CHAPTER 6   DESIGN REVIEW OF CHENNAI PERIPHERAL RING ROAD (CPRR)

6.1.1   Objectives and Scope of Design Review of CPRR

In order to confirm the reasonability of providing the Japan International Coordination Agency (JICA) Loan to the CPRR Project, the review is undertaken on the design made in the Detailed Project Report (DPR).

Figure 6.2.1   Alignment at Ch.99+600 and Drivers' View

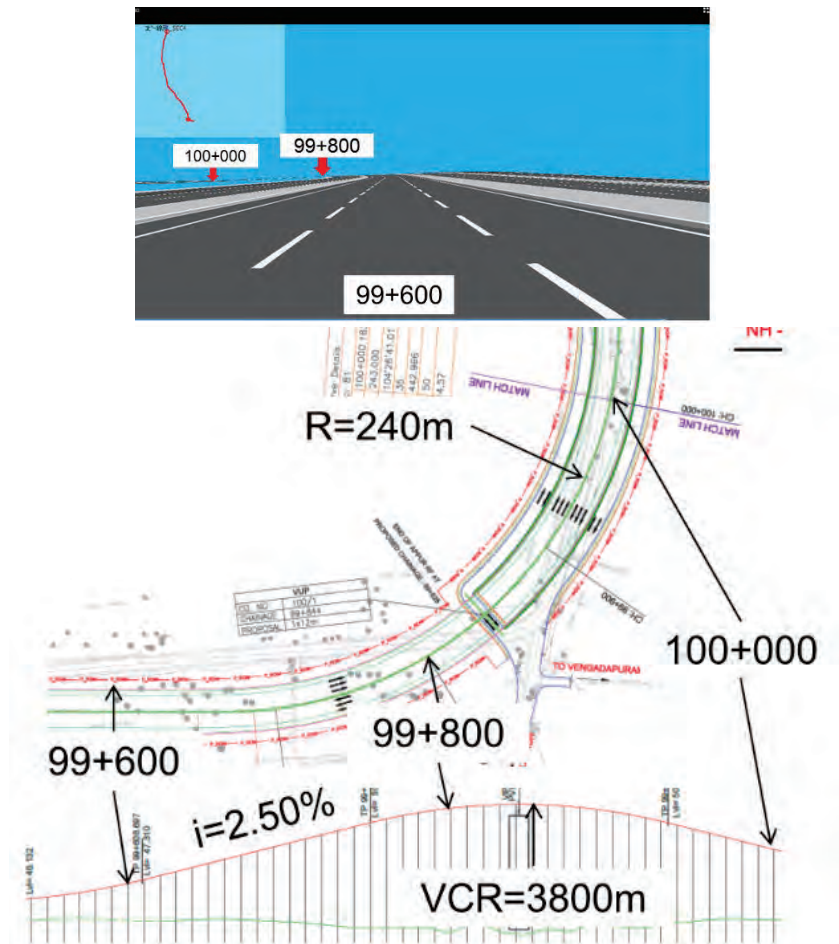
In the alignment proposed in the DPR, especially in Section 4 which adhered to the alignment of the existing road, there are some sections where the horizontal and vertical alignments are not well-balanced. It is desirable for these sections to be improved in the detailed design stage of the Project. Figure 6.2.1 shows the alignment around Ch.99+600 where a relatively small curve is situated near the top of the crest curve that creates unfavorable situations in terms of visibility.

Figure 6.2.2   Crossing at Entry and Exit Ramps

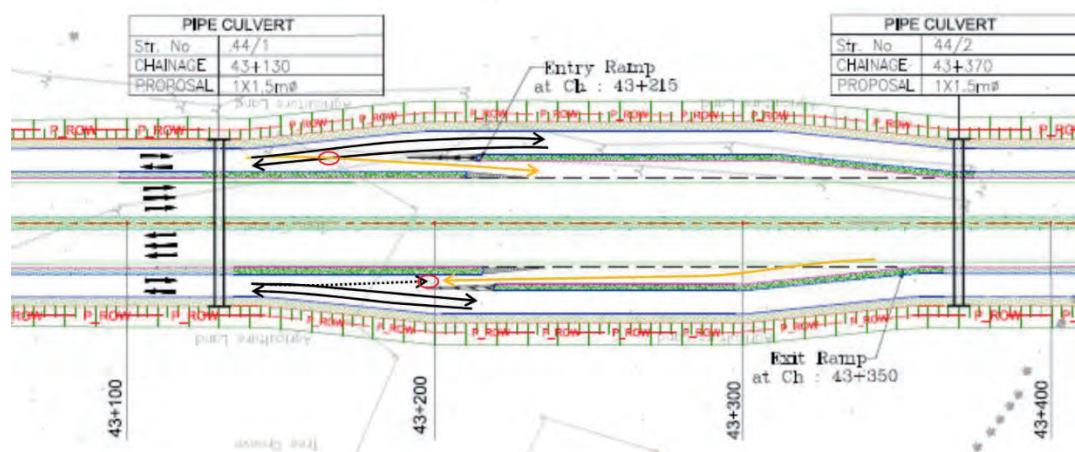
In the design made in the DPR, two-lane service roads that are to be operated as two-way roads are proposed on both sides of the main road. It is planned that the main road and the service road are separated by dividers in the general section, and vehicles may come in and out at entry and exit ramps. However, this system requires crossing at entries to reach the main road. Furthermore, there is a concern of incursions and collisions at exits. Therefore, it is recommended for the service road to have one-way operation at least in the vicinity of entries and exits.

Figure 6.2.4   Plan of the Present Design of Beginning Point

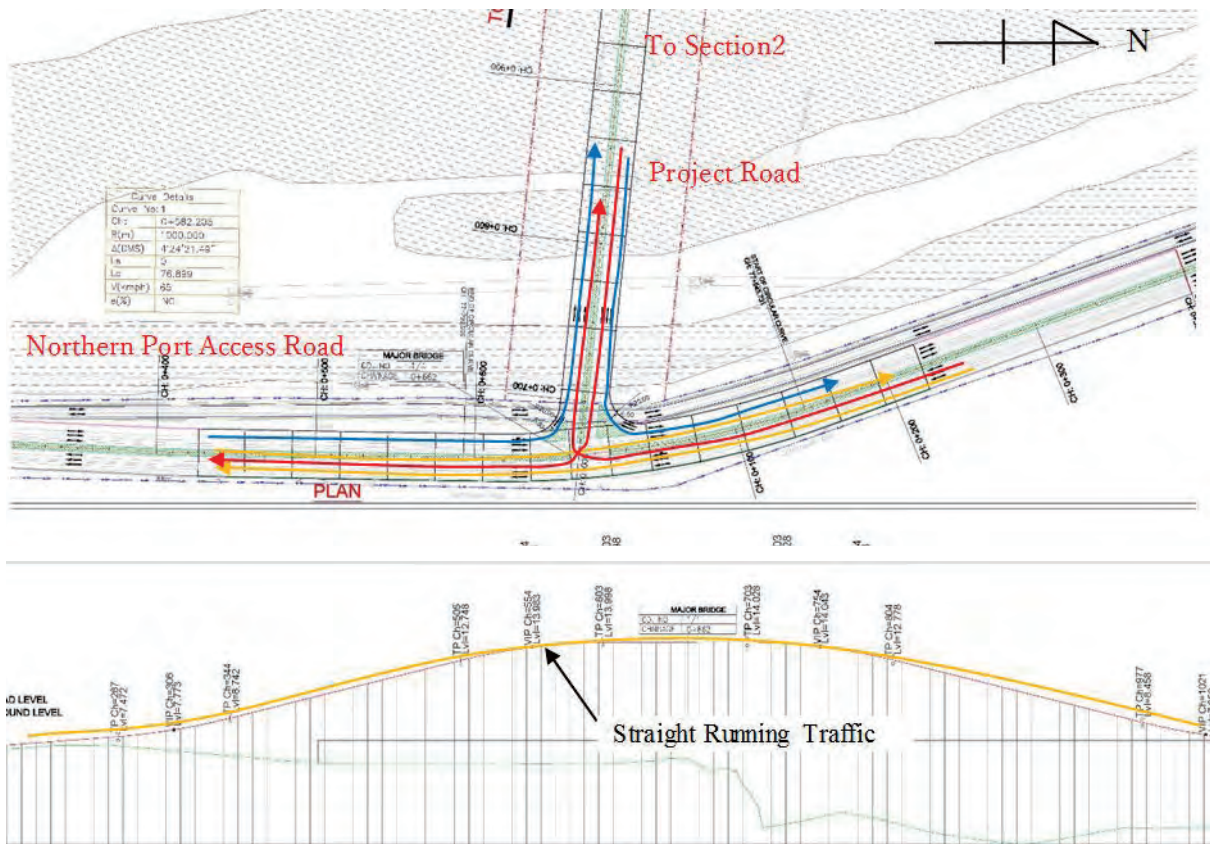
The directions of traffic passing the intersection are straight (south ⇔ north), left turn (south → west, west → north), and right turn (west→south, north→west). Because vehicles going straight intersect with the right-turning vehicles, a traffic signal (three phases) is planned at this at-grade intersection. The plan of the present design is shown in Figure 6.2.4.

Figure 6.2.7   Plan and Profile of the Present Design of Bifurcation Point

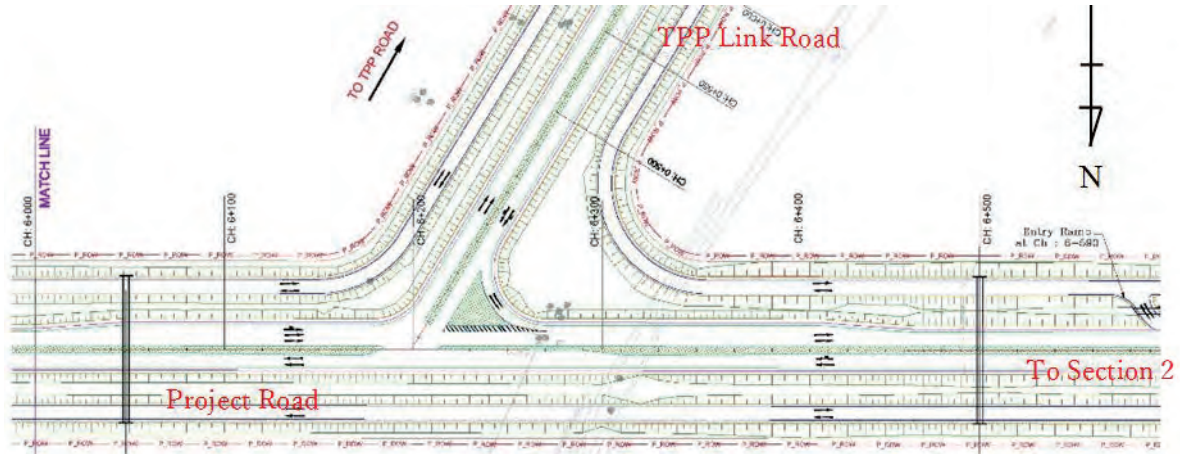
The directions passing the intersection are straight (west⇔east), left turn (east→south and south→west), and right turn (west→south and south→east). Because vehicles going straight intersect with right-turning vehicles, a traffic signal (three phases) is planned at the at-grade intersection. The plan of the present design is shown in Figure 6.2.7.

Figure 6.2.13   Projected Plan and Profile

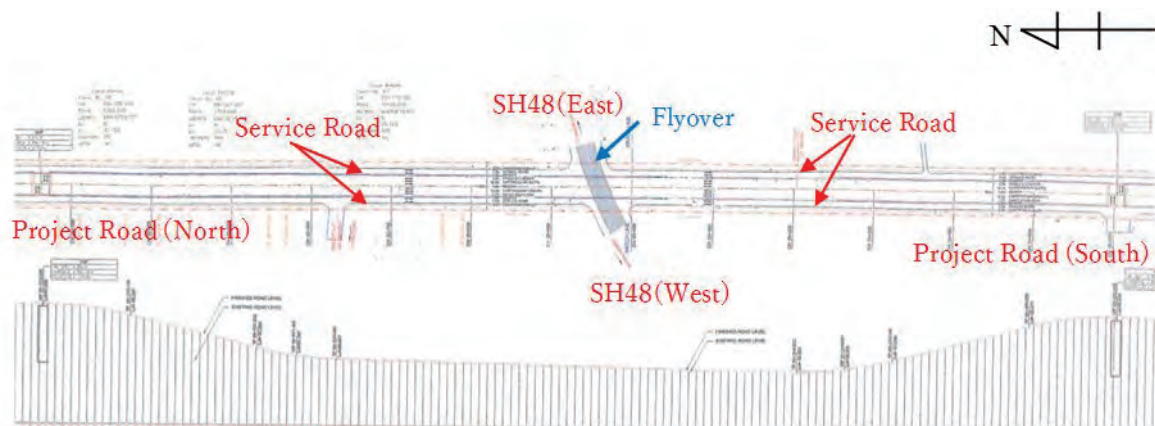
The project road is not connected with SH48, and only passes under the flyover of SH48. Therefore, the project road will be connected with SH48 using the opening of the side separator of the project road and passing through the service road installed outside of the project road. The plan of the present design is shown in Figure 6.2.13.

Source: JICA Study Team added to DPRR
Figure 6.3.14   Recommended plan for IC-4

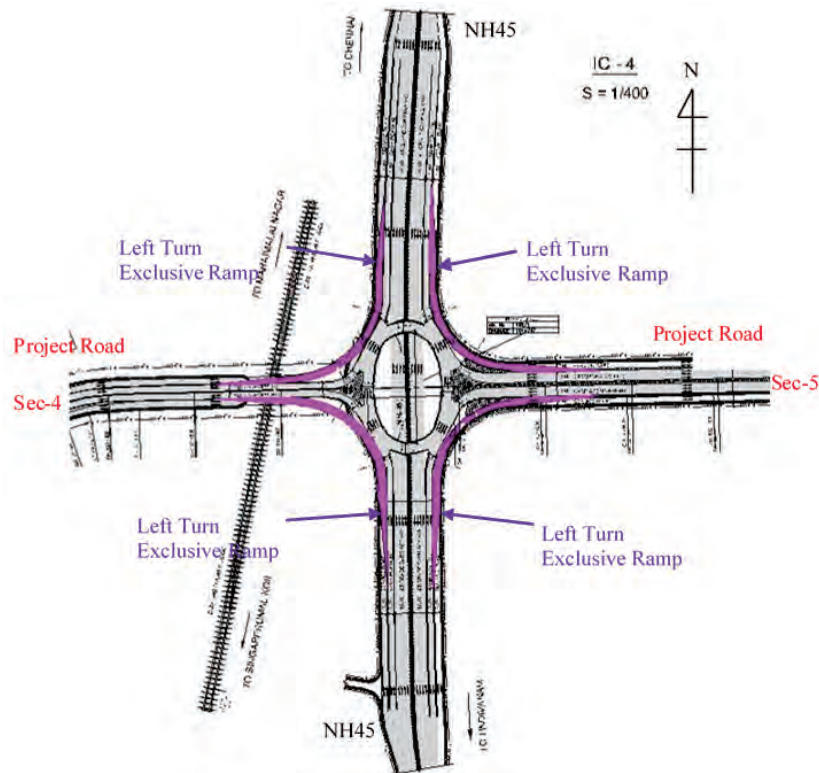
This interchange is planned at the area where NH45 and railway are near. Therefore, the elevated roundabout type is adopted as the interchange. The shape of the roundabout is elliptical, having a small radius of 35 m and a big radius of 100 m. The distance between the merging nose and the diverging nose is longer and the on-ramp and the off-ramp are separated in order to decrease the influence of weaving. However, it is expected that congestion will be caused by weaving, considering the future traffic volume.

It is recommended to add a separate left-turn rampway outside the roundabout in order to increase the capacity of the roundabout.

Figure 6.4.5   Bridge Cross Section（MJB101）

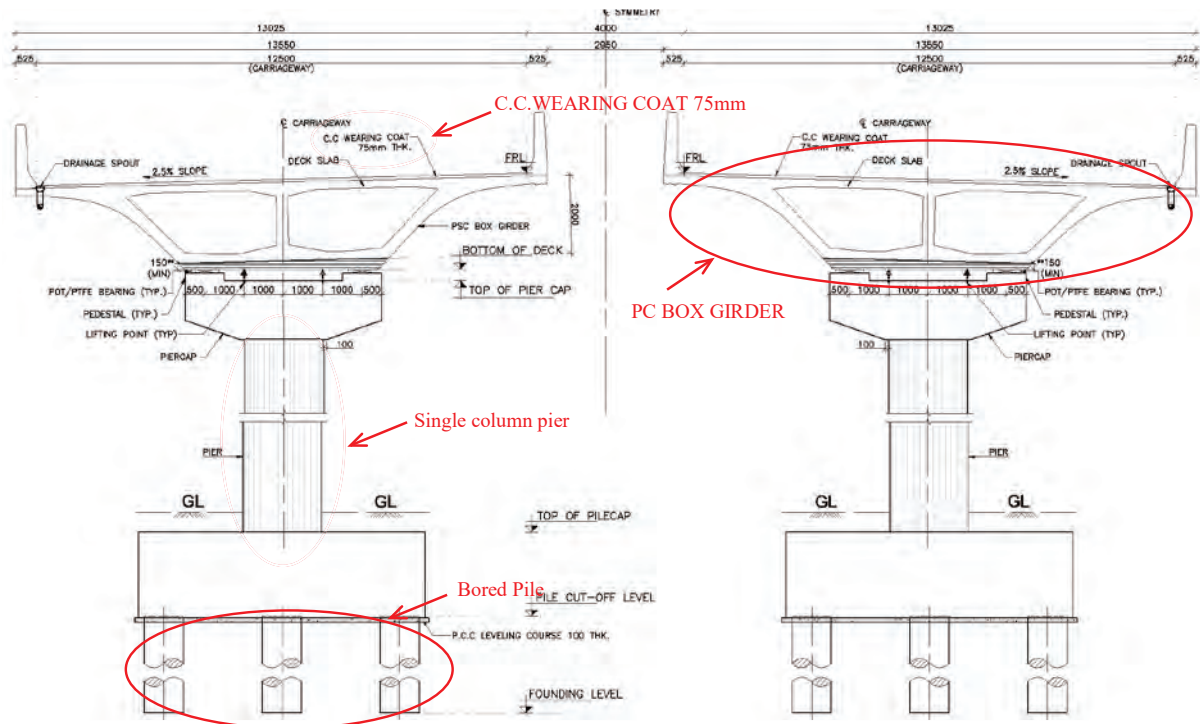
In the final DPR, the planned bridge pavement material is concrete. However, asphalt pavement is used in the vicinity of the earthworks section as well as the ORR, while concrete asphalt is used in the already constructed bridge at the end of Section 4. Although material procurement could be the main consideration, other factors such as consistency must also be considered in the determination of pavement material during the detailed design.

Figure 6.4.7   MJB501 : Type of Substructure Located at Bridge Ends (Abutment)

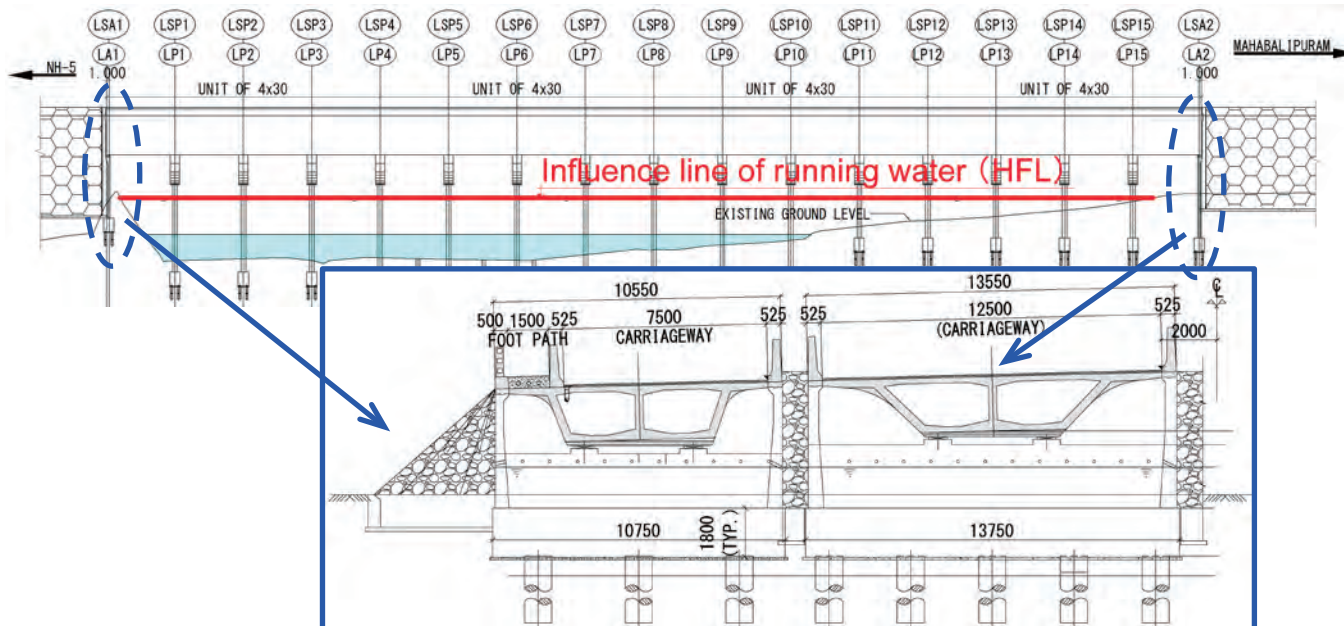
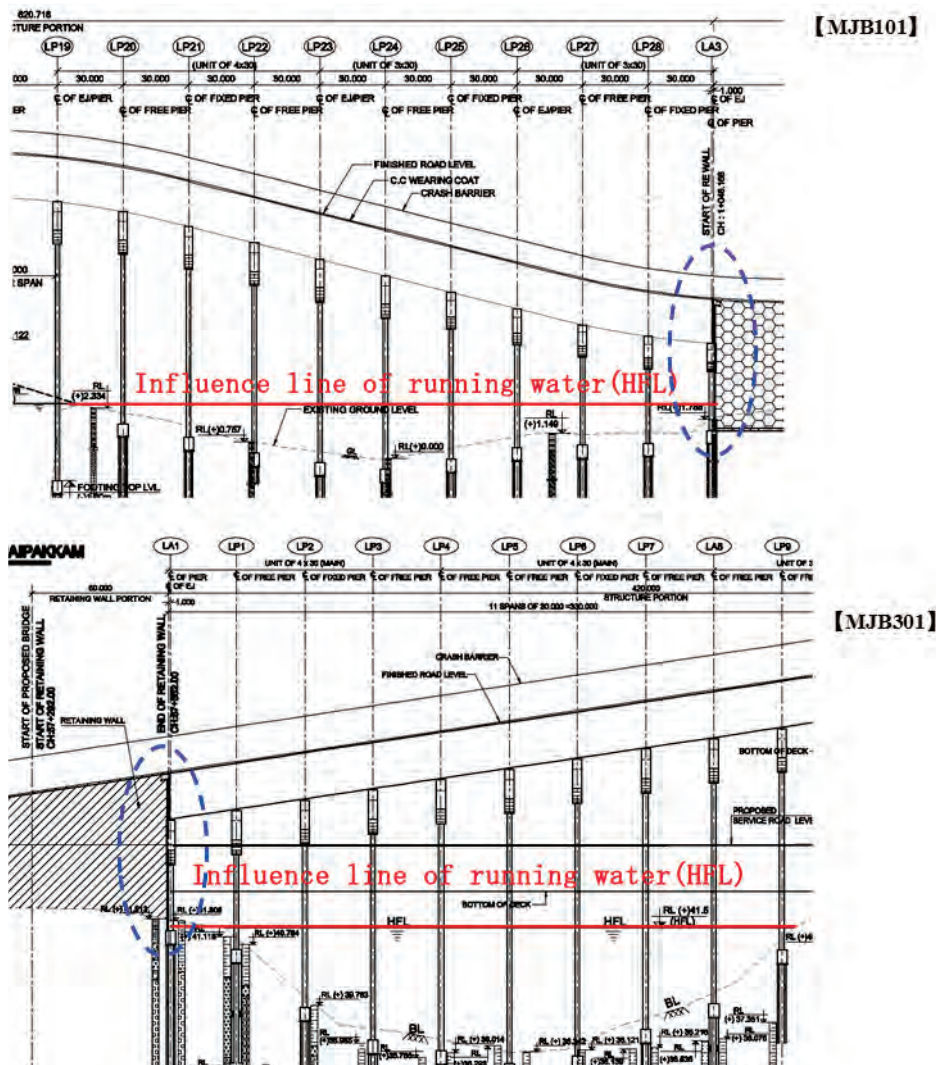
In CPRR, the height of the reinforced earth wall at both ends of the bridge tends to be larger than average. The objective is to shorten the bridge by increasing the height of the reinforced earth wall. In general, it is said that the actual height and the empirical standard height are about 12 m at maximum; thus, it was verified whether the reinforced soil wall height planned in the CPRR exceeds the said value or not.

Source: DPR Plan&Profile(14518/E/PP/DD209), Drawing（14518/E/MJB202/DD001: SH-1 OF 3）
Figure 6.4.10   Mistake in Plan & Profile

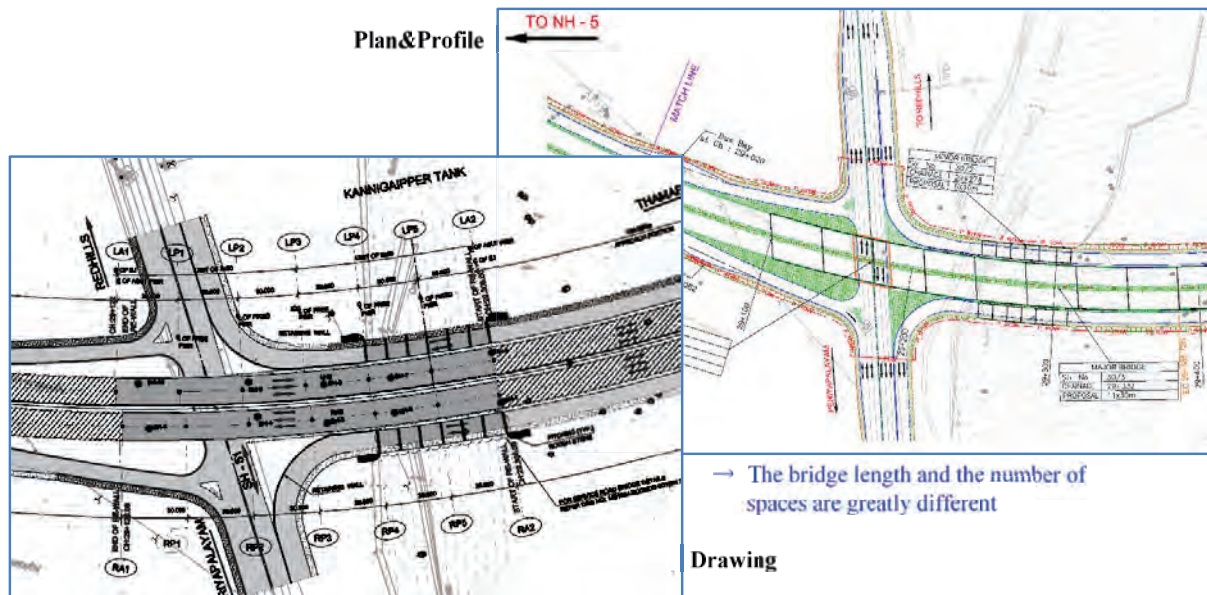
There is a lot of difference in the Plan &Profile and the Drawing of the structure of MJB202 (Str. 30/3). Based on the topography, the content of the Drawing is correct. It is considered that there is a mistake in the updated Plan & Profile. Therefore, a correction is being suggested.

Figure 6.4.12   Bridge Cross Section（MNB101）

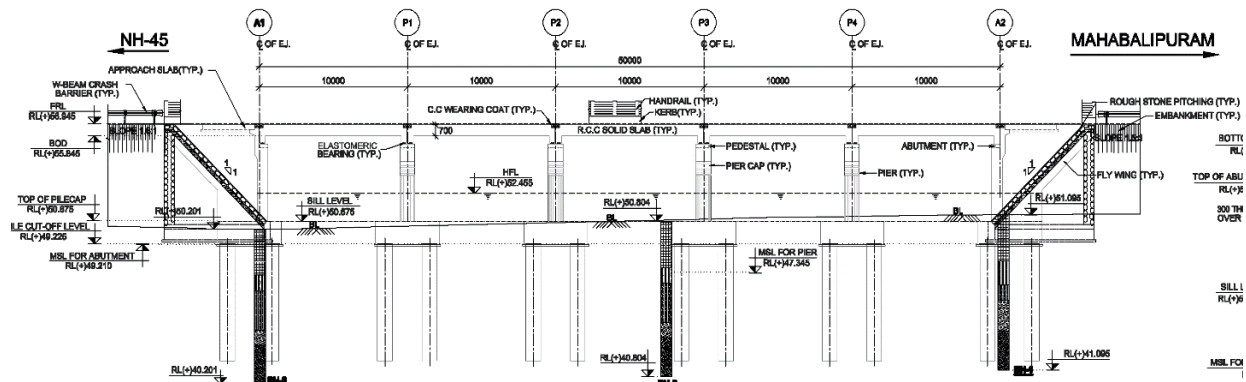
In the final DPR, the planned bridge pavement material is concrete. However, asphalt pavement is used in the vicinity of the earthworks section as well as ORR, while concrete asphalt is used in the already constructed bridge at the end of Section 4. Although material procurement could be the main consideration, other factors such as consistency must also be considered in the determination of pavement material during the detailed design.

Source: JICA Study Team based on DPR（Drawing: ROB101）
Figure 6.4.18   Bridge Cross Section（ROB）

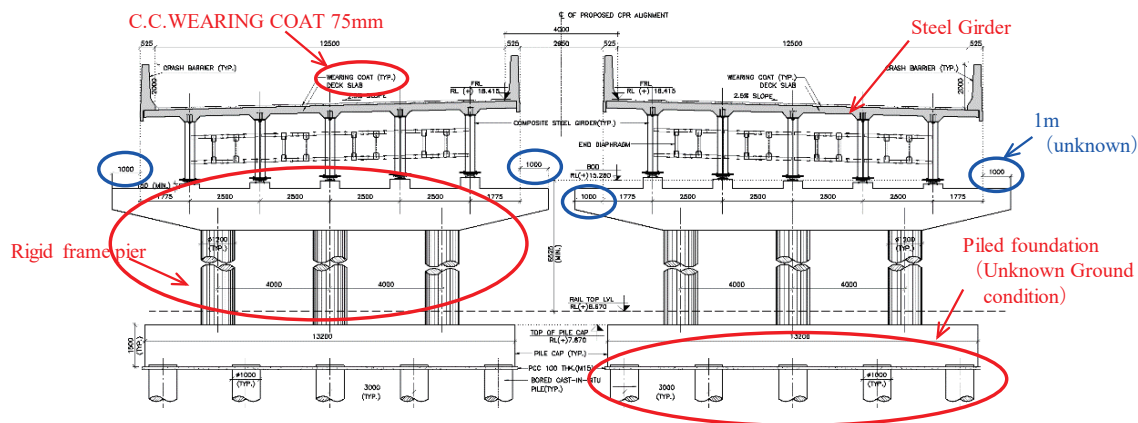
The plan of 1.0-m lengthening of the substructure girder is not described in the DPR and the setting conditions are unknown.

Figure 6.4.20　　VUP Shown in the Plan&Profile

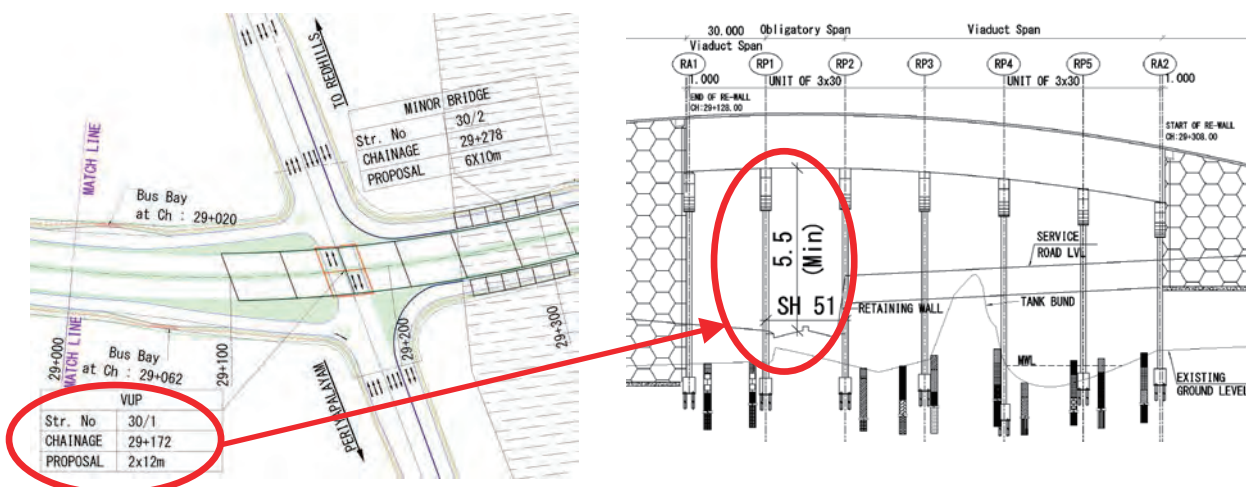
Since MJB is located at the same location as VUP (Str. 30/1) as described in Plan & Profile, the VUP is considered unnecessary. It is proposed to revise the plan upon confirmation.

Source: JICA Study Team based on DPR（Drawing: 14518/E/IC/NH5/DD-001, SHEET 2 OF 3）
Figure 6.4.25   Vertical Clearance（IC/NH5）

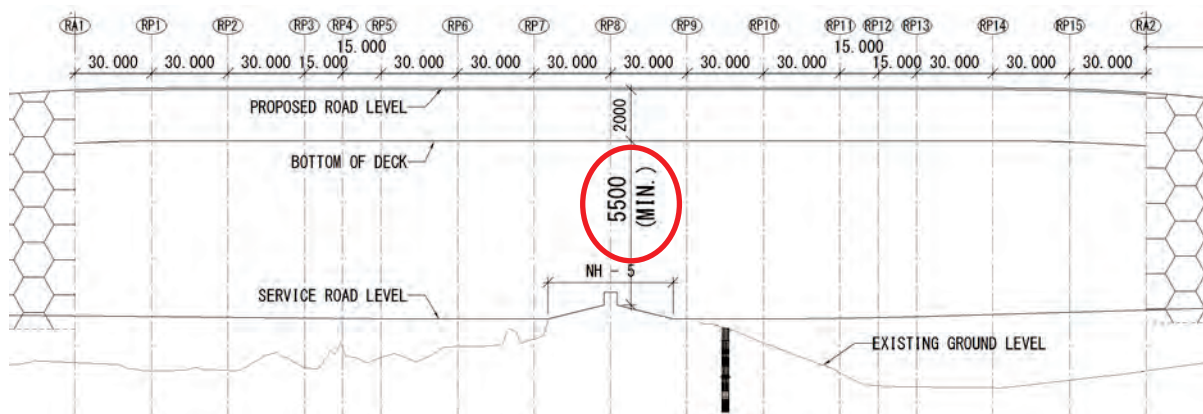
For the IC, the longitudinal alignment has been determined so as to secure a building limit of 5.5 m from the intersecting NH, and it is concluded that there is no particular problem with regard to this plan.

Source: JICA Study Team based on DPR（Drawing: 14518/E/IC/NH5/DD-001, SHEET 2 OF 3）
Figure 6.4.26   Bridge Cross Section（IC/NH5）

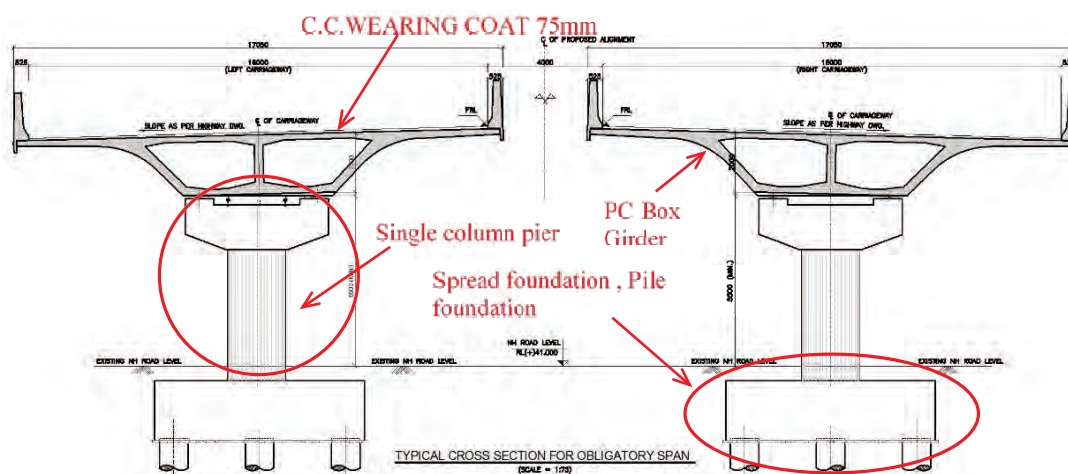
In the final DPR, the planned bridge pavement material is concrete. However, asphalt pavement is used in the vicinity of earthworks section as well as ORR while concrete asphalt is used in the already constructed bridge at the end of Section 4. Although material procurement could be the main consideration, other factors such as consistency must also be considered in the determination of pavement material during the detailed design.
